Our Ref: 3034-01/JW

PROPOSED CHRISTMAS FARM, LAND TO THE SOUTH OF LLAY ROAD, CEFN-Y-BEDD, WREXHAM

PLANNING APPLICATION REFERENCE P/2022/0681

ENCLOSURE 1 – LHA COMMENTS DATED 03/02/23

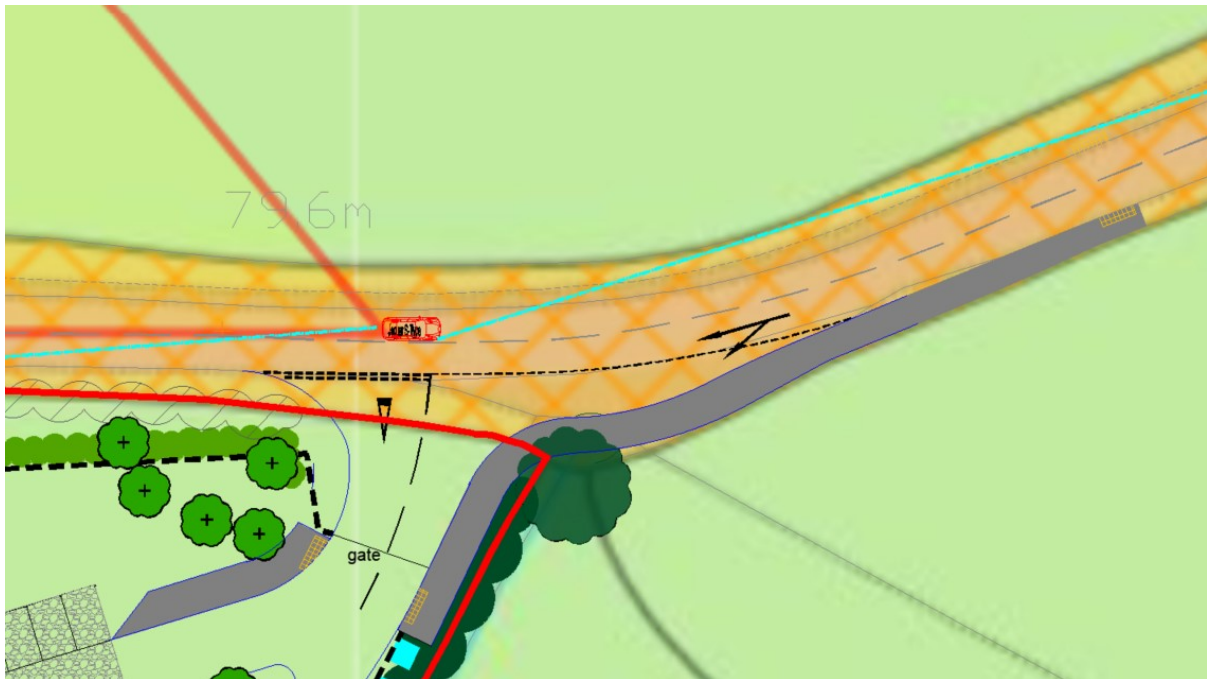
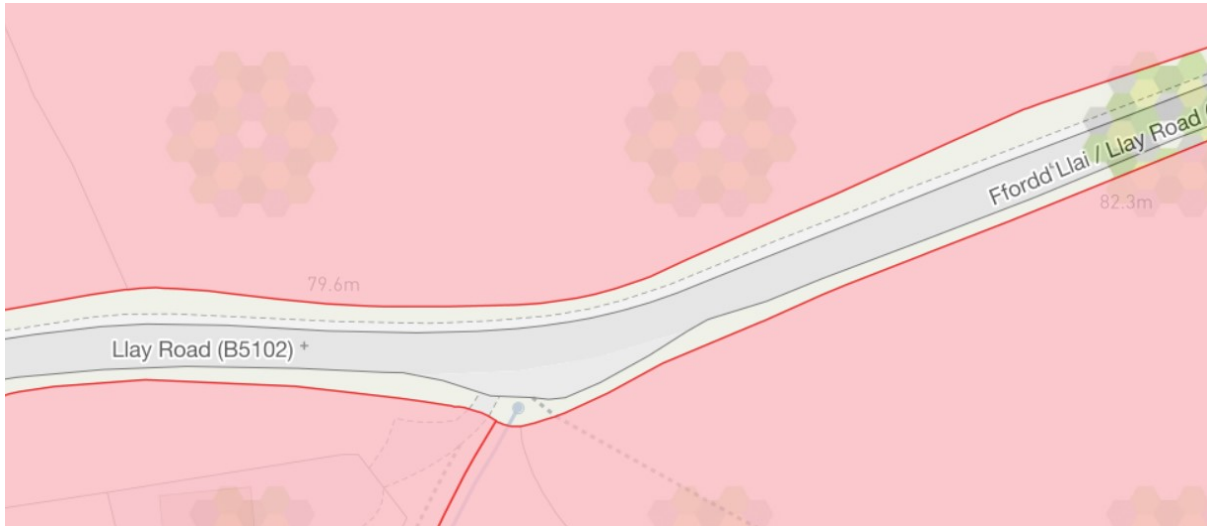
Comment 2: “The forward visibility splay shown on the drawing for 158m from a vehicle approaching the site from the west is achieved, where the splay touches the footway. However, the forward visibility splay shown on the drawing for 147m between a vehicle waiting to turn right into the site and a vehicle approaching the site from the east, is not achieved due to the existing hedgerow located on the northern extents of Llay Road obstructing the splay. The development site access as it is currently proposed cannot be approved, since inadequate visibility splays is a highway safety concern.

To achieve the required SSD visibility, the vegetation located on the northern side of Llay Road, within the extents of the visibility splay, will need to be cleared. It is noted that the hedgerow on the northern extents of Llay Road is not within the applicant’s current ownership.”

The assertion that the requisite 147m forward visibility splay from vehicles approaching from the east towards vehicles turning right into the site is not achievable, without third party land, is technically incorrect.

The extent of the adopted highway boundary has been obtained from the WCBC website (weblink [here](#)) and underlaid onto AXIS drawing number 3034-01-D02B.

A screenshot showing this exercise is provided below. Note that the adopted highway is shown in yellow hatch and the 147m forward visibility splay is shown in cyan:-

As shown above, the forward visibility splay falls wholly within the adopted highway boundary.

This is reinforced by land ownership boundary information obtained from HM Land Registry, which runs fully contiguous with the adopted highway record on the Council's website:-

It should however be reiterated that the visibility splay is achievable within the confines of the adopted highway boundary and without recourse to third party land.

**ENCLOSURE 2 – DRAWING NO. 3034-01-D02B: PROPOSED SITE ACCESS
ARRANGEMENTS AND VISIBILITY SPLAYS**

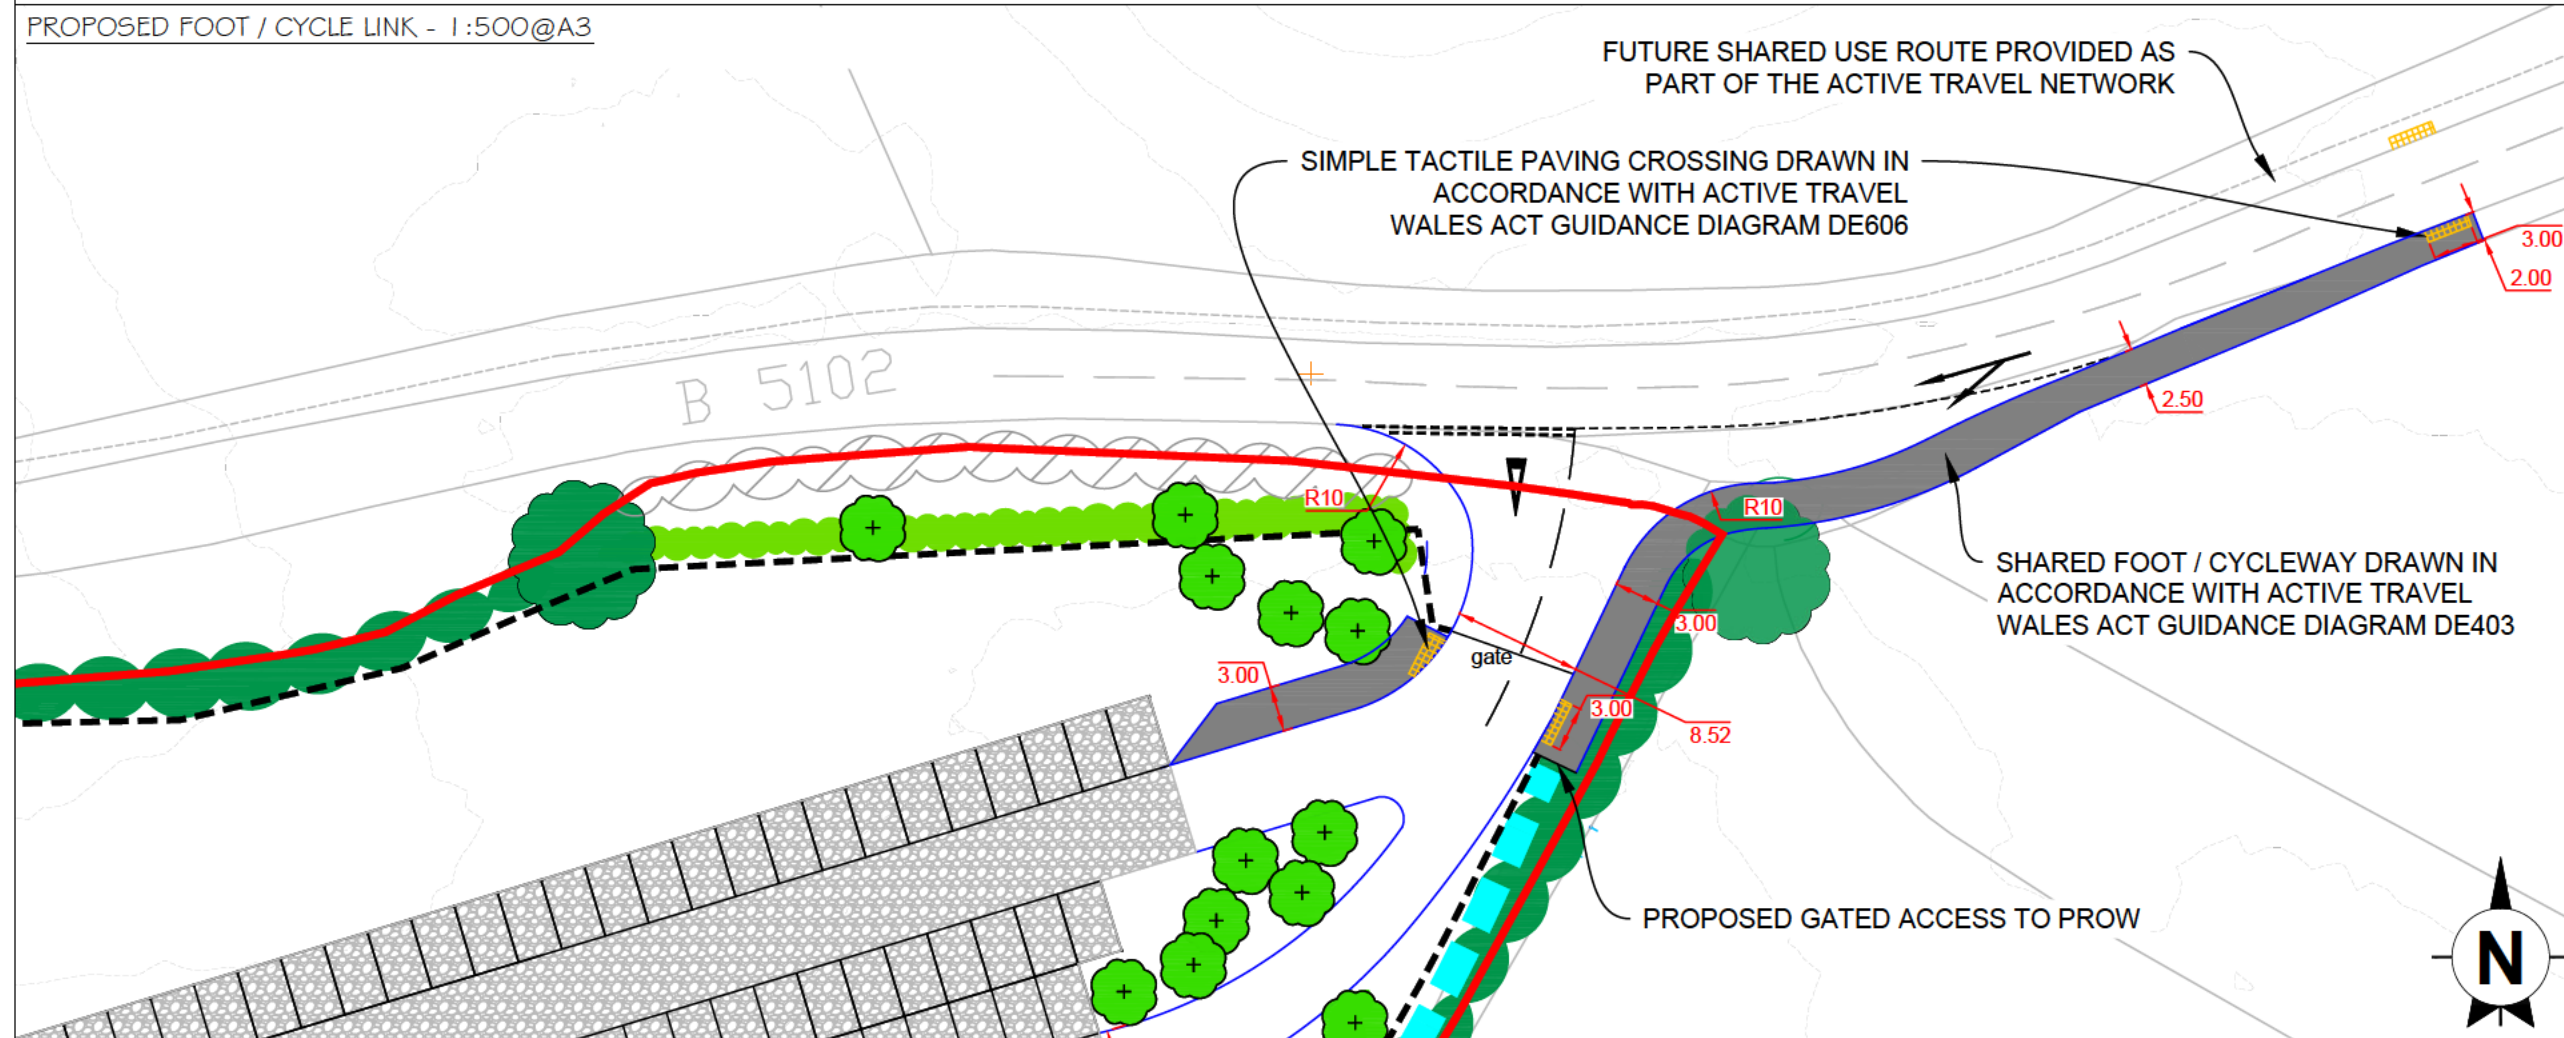
Comment 5: "The revised 'Site Access Arrangement and Visibility Splays' drawing (Drawing No. 3034-01-D02A) illustrates the site access has been amended to include a 3m shared foot / cycleway leading into the site and a tactile paving crossing point integrating the site into the proposed future Active Travel Network infrastructure on the northern side of Llay Road. Although the crossing point is welcomed, there is concern that the visibility on the northern side of Llay Road adjacent to the crossing point is

impeded by the bend in the road. It is suggested the tactile crossing point is relocated further east on Llay Road so as the adjacent crossing point will have better visibility for pedestrians waiting to cross and vehicles will also have better visibility of pedestrians, particularly if speeds are higher than the speed limit. Since there is an existing footway on the northern side of Llay Road, a tactile crossing point should be provided adjacent to the proposed tactile on the southern side of Llay Road to facilitate crossing in the interim."

As indicated above, the suggestion to locate the proposed tactile paving crossing point further to the east and to provide tactile paving on both sides of Llay Road is accepted. **Drawing No. 3034-01-D02B** in **enclosure 2** and **Drawing No. 3034-01-ATR01B** in **enclosure 3** show the revised crossing arrangements. The proposed foot / cycleway will be provided to a minimum width of 2.0m, widening to 2.5m and then 3.0m within the site. The proposed crossing point is positioned away from the bend to provide greater pedestrian visibility whilst crossing, as suggested in the most recent comments.

ENCLOSURE 3 - DRAWING NO. 3034-01-ATR01B: SWEPT PATH ANALYSIS

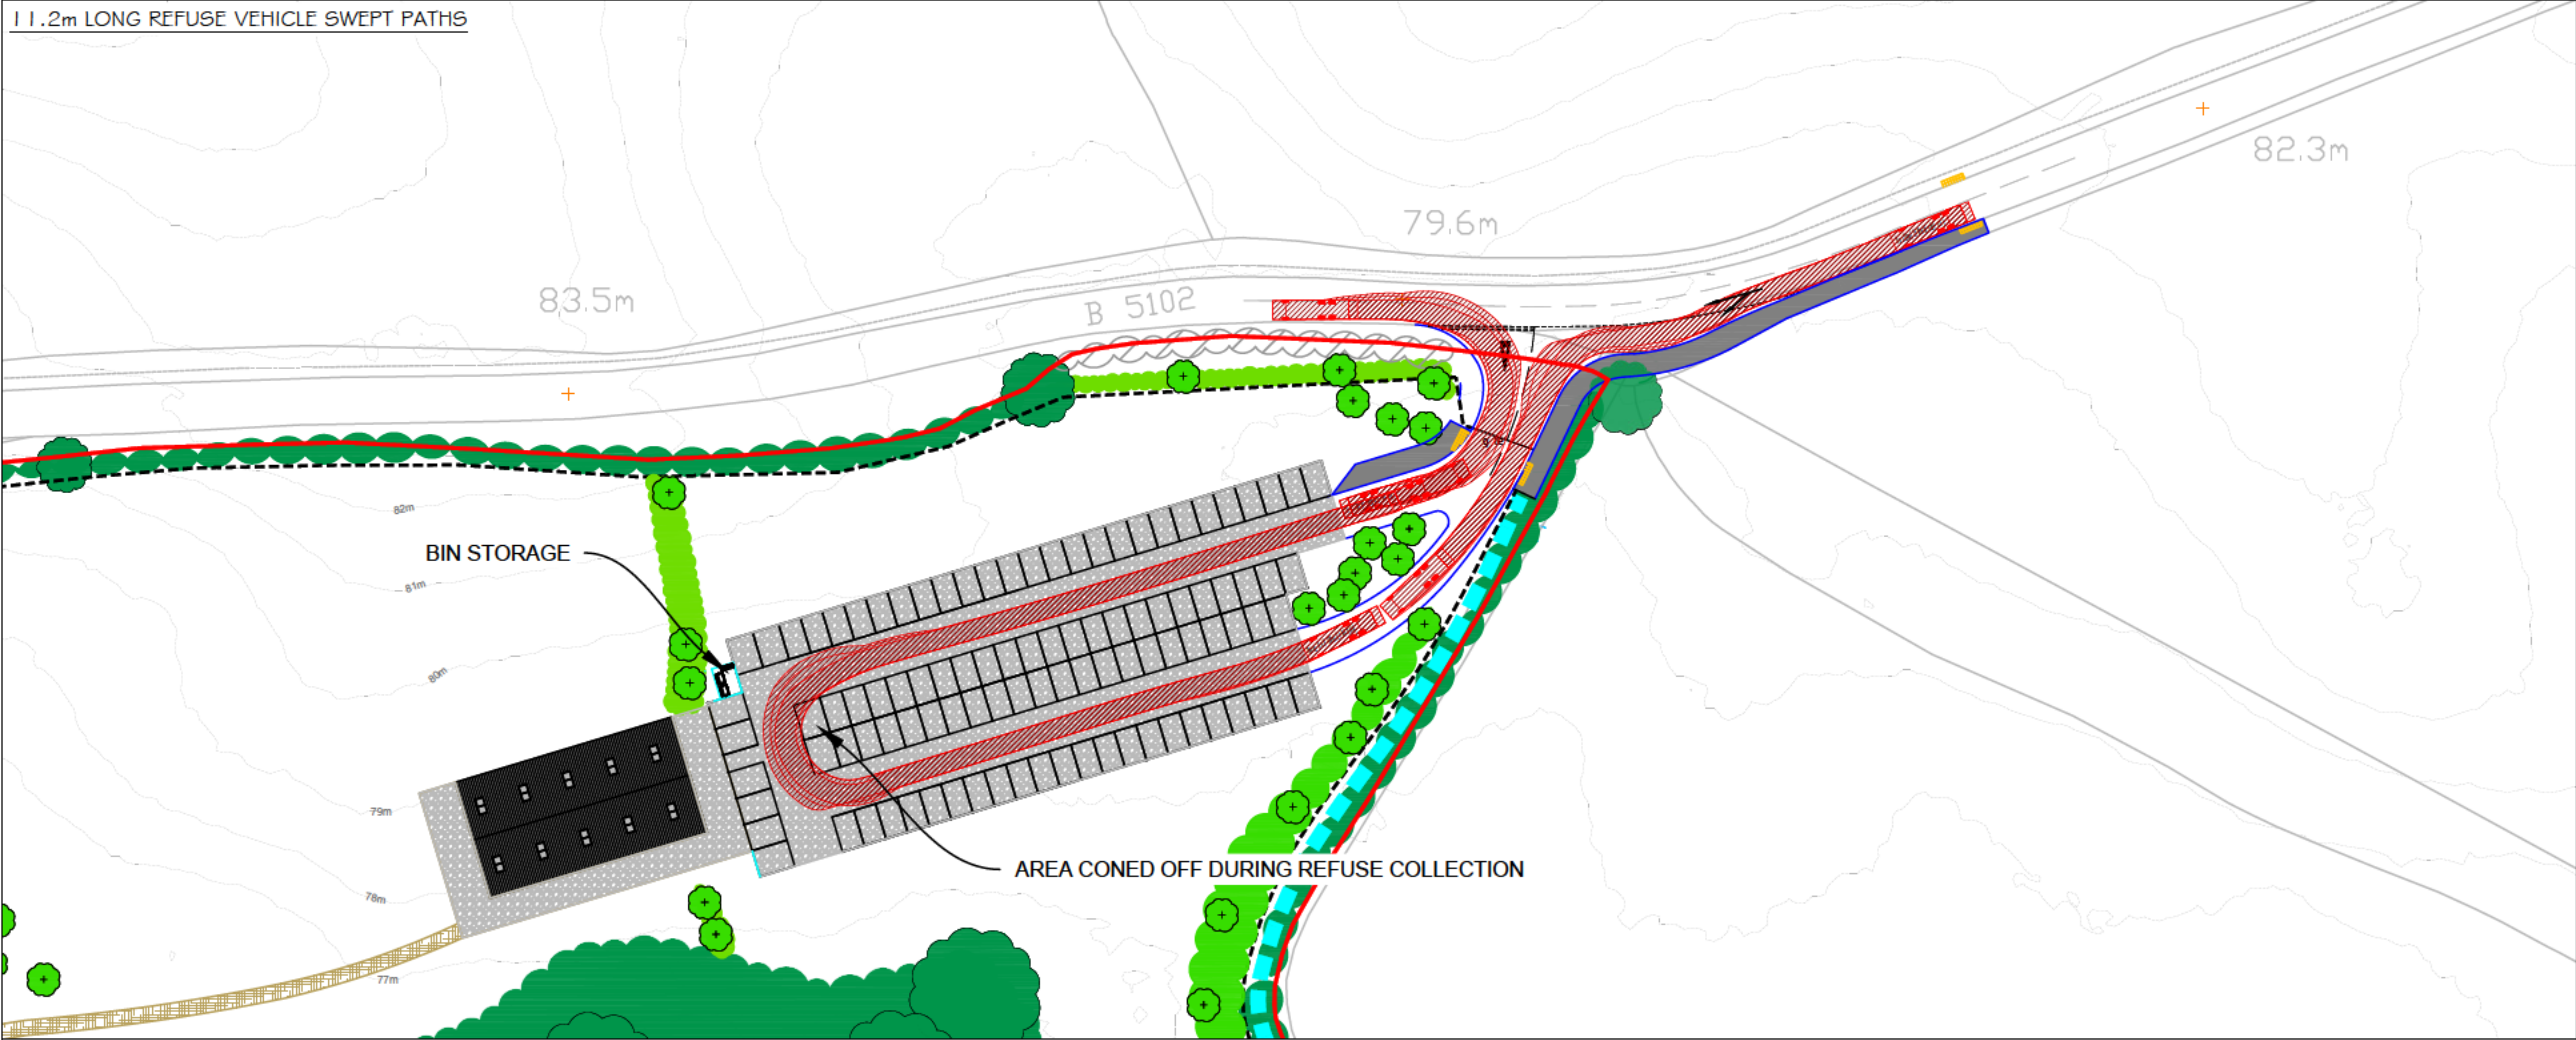
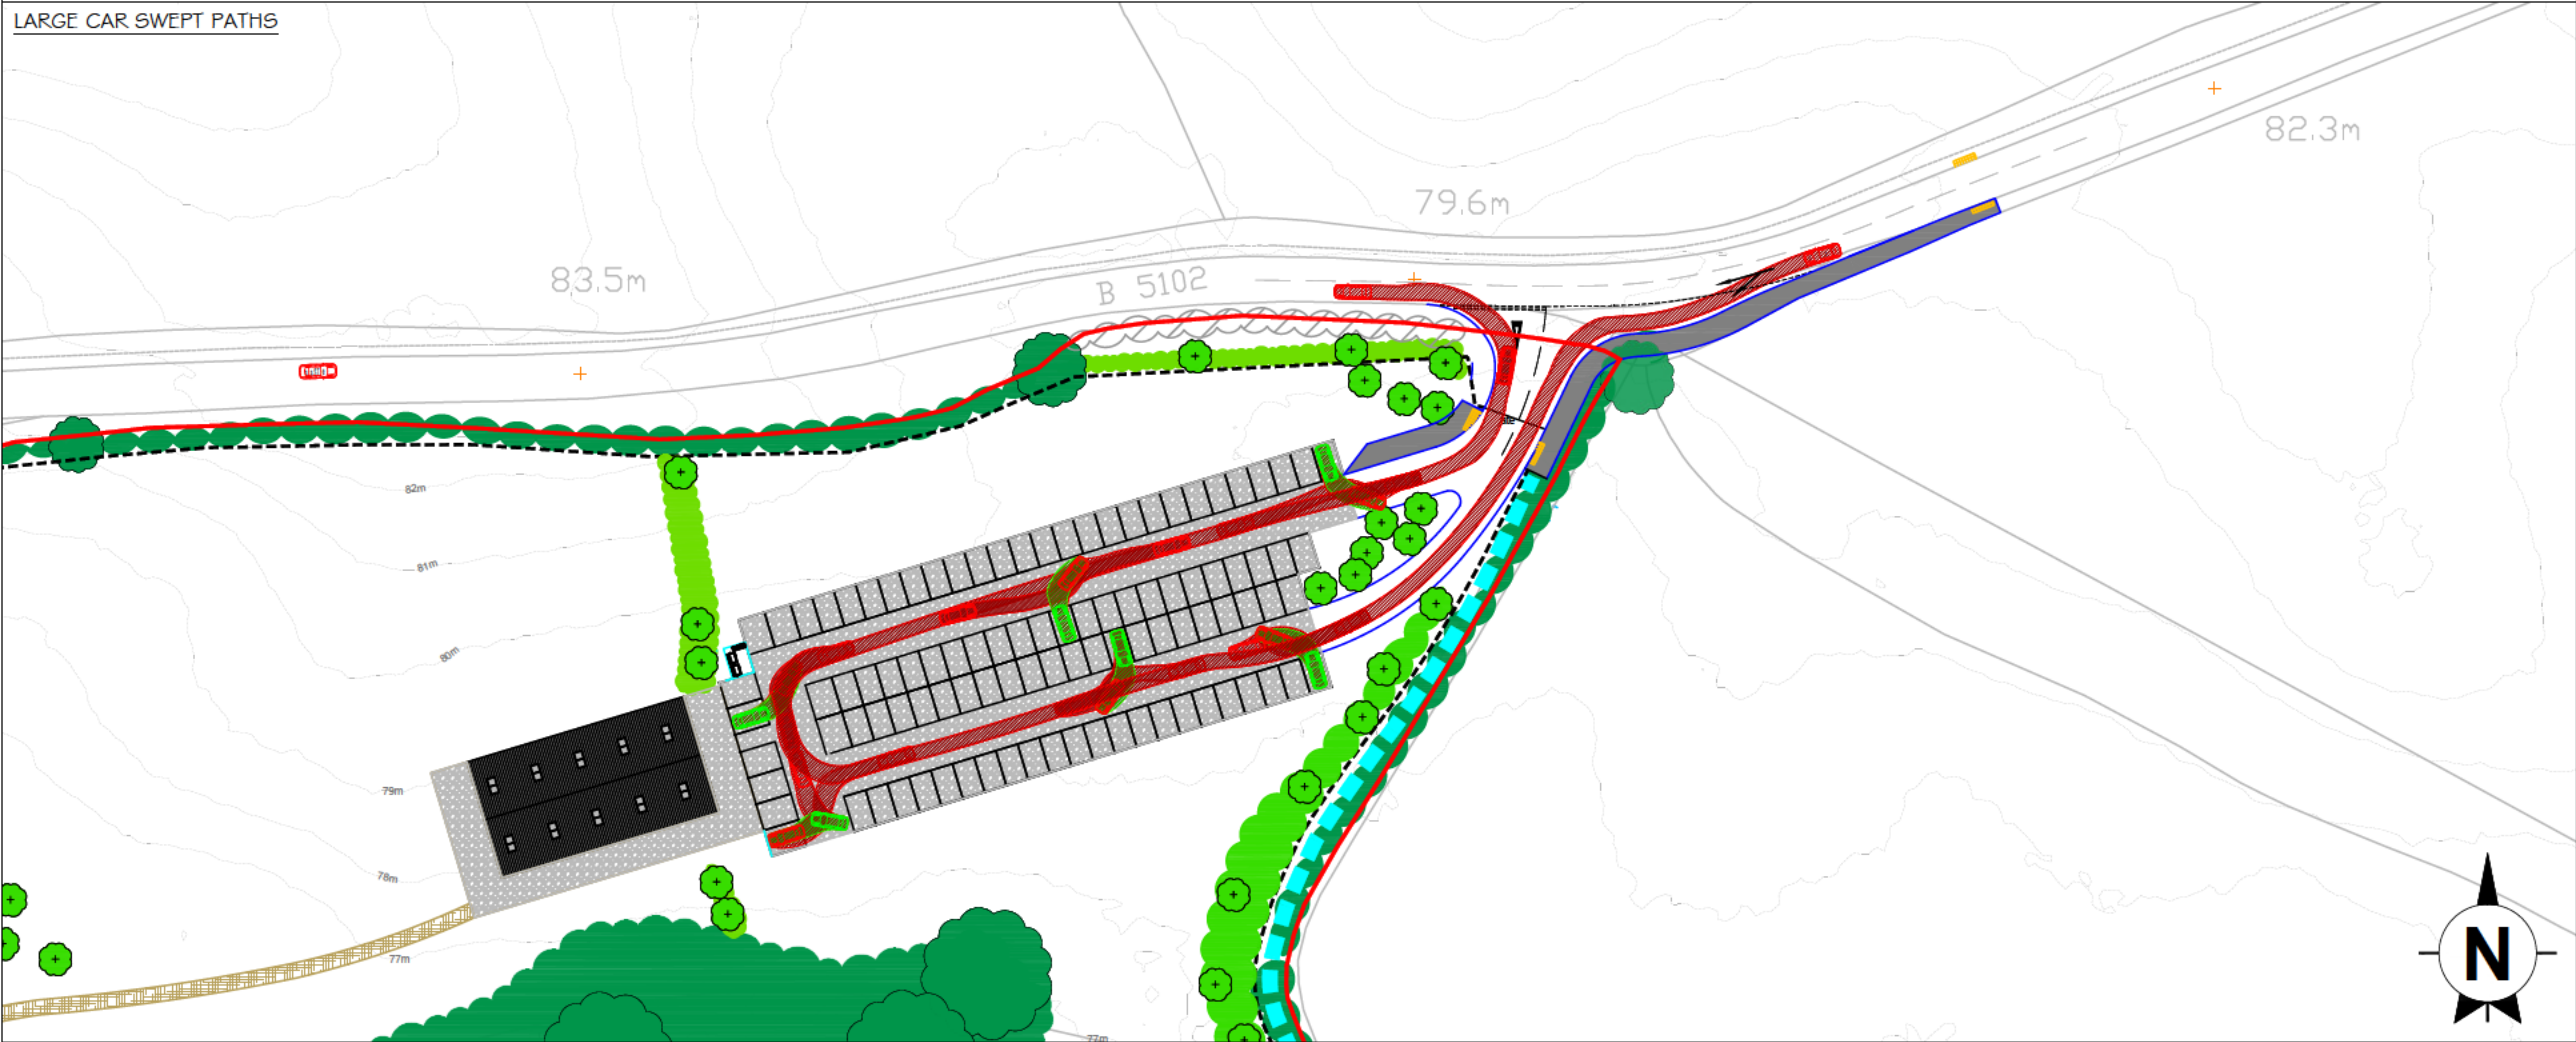
Comment 4: "Sustainable travel to the proposed development is encouraged however, it is noted that the existing footway on the northern side of Llay Road is narrow and not suitable for all users. The applicant has provided detail regarding Active Travel improvements proposed, as discussed, and agreed with WCBC's Active Travel officer (Daniel Morris). Although there is an aspiration to introduce Active Travel infrastructure on the northern side of Llay Road there are currently no designs drawn up. Timescales for the delivery of improvements to the footway on Llay Road should be clarified as if the development site becomes popular and visitors choose to walk to the site, the current arrangements are not adequate."

Nonetheless, further improvements to the footway and crossing arrangements have been made to the proposed site access drawing (shown on **Drawing No. 3034-01-D02B** in **enclosure 2** and **Drawing No. 3034-01-ATR01B** in **enclosure 3**), which are considered to be proportionate to the modest scale and nature of the proposed development.

Revision History		Date
A	FOOT / CYCLE ARRANGEMENTS BASED ON COMMENTS PROVIDED BY ACTIVE TRAVEL OFFICER	03.11.22
B	FOOTWAY EXTENDED TO EAST	17.2.23
